SIL 10-TC10-18
April, 2018
Page 1 of 2

SUBJECT: TC10® Internal Wiring Harness Speed Sensor Connector Color Change

MODELS AFFECTED: TC10® Product Family Transmissions

Figure 1. Internal Wiring Harness Speed Sensor Connector Locations

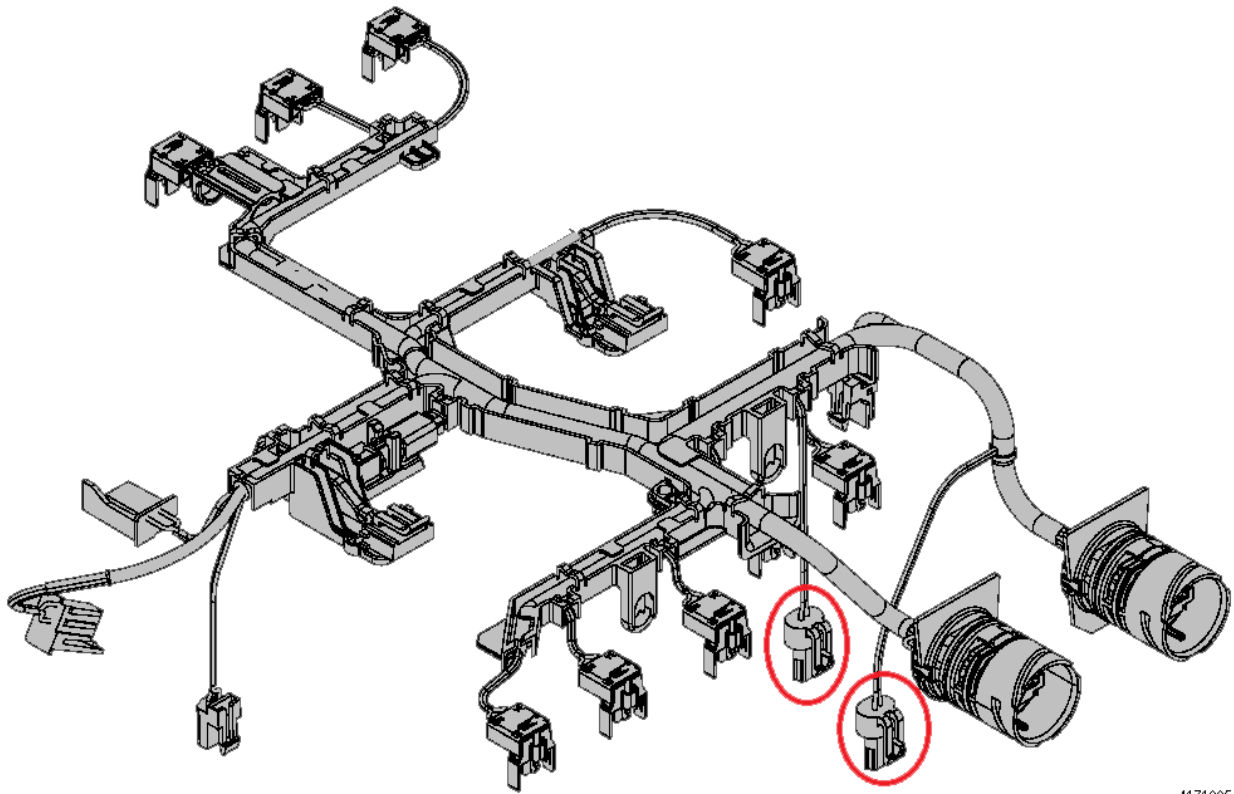
The two black speed sensor connectors on the internal wiring harness will be changed to gray (refer to [Figure 1](#)). There will be no P/N change to the existing internal wiring harness (P/N 29554690).

The alteration to the connectors of the internal wiring harnesses will offer full backward and forward compatibility, causing no impact when repairing a transmission or when used in the building of Allison ReTran® Transmissions.
